Reference your letter dated April 23, 2001 with the comments resulting from your review of our draft Nuclear Regulatory Commission (NRC) License Termination Plan.

Resolution of Comments for Draft License SUB-1435
Termination Standard Review Plan No. 26-MA-5970-01
Jefferson Proving Ground, Madison, IN

SAVE THE VALLEY COMMENTS ON DRAFT LICENSE SUB-1435 TERMINATION STANDARD REVIEW PLAN, NO. 26-MA-5970-01, JEFFERSON PROVING GROUND, MADISON, INDIANA, FEBRUARY 2001

Earthquake Hazards

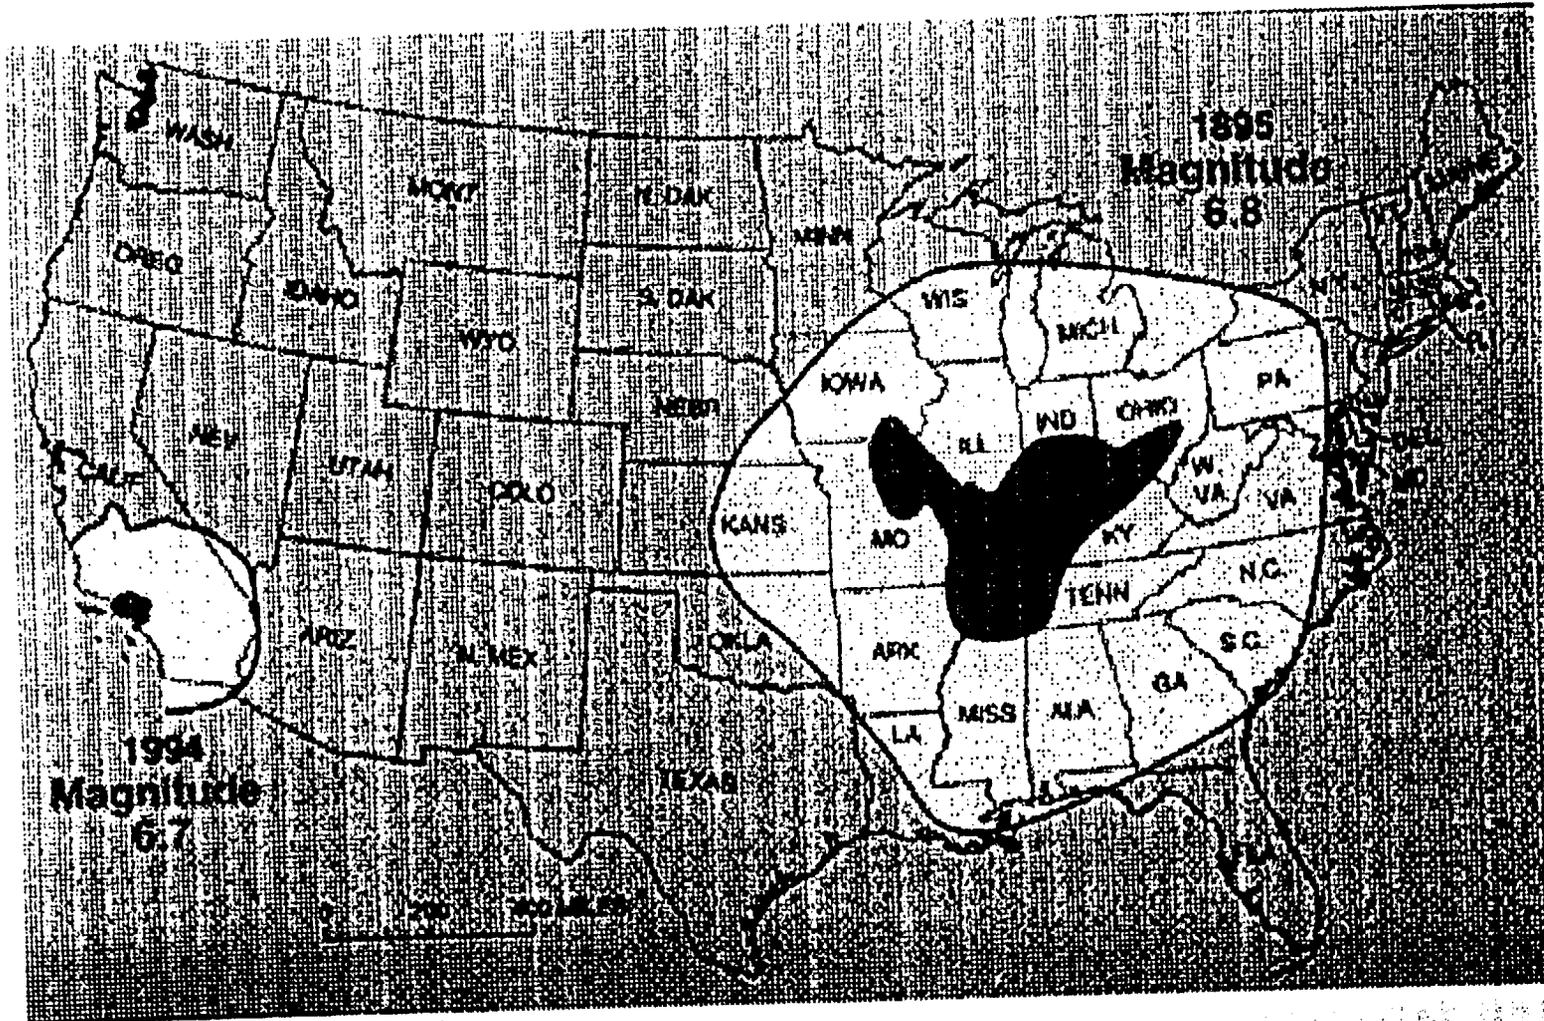
Comment 2: Section 3.5, Geology and Seismology. (Points of comments). Impact(s) of karst terrain should be more fully investigated and addressed. Mention made of earthquake activity.

This section indicates that there have been three (3) historical earthquakes with a magnitude of three or more within 200 miles of the site over approximately the last one hundred (100) years. Also, according to the U.S. Geological Survey: "In the past decade, there has been increasing awareness that the seismic hazard in the Eastern United States could be greater than the historic earthquake record suggests." (see APPENDIX B) Earthquakes at or near the DU Impact Area have the potential to alter the geology and landscape of the area. Such alteration could change,

among other things, the surface and groundwater flow dynamics of the area, possibly creating new or different migration paths.

Response 2: In an ideal case karst terrain could be further investigated. However, due to the extensive presence of unexploded ordnance (UXO), further investigation would be a severe human safety concern and is beyond the scope of the document. Thank you for earthquake information.
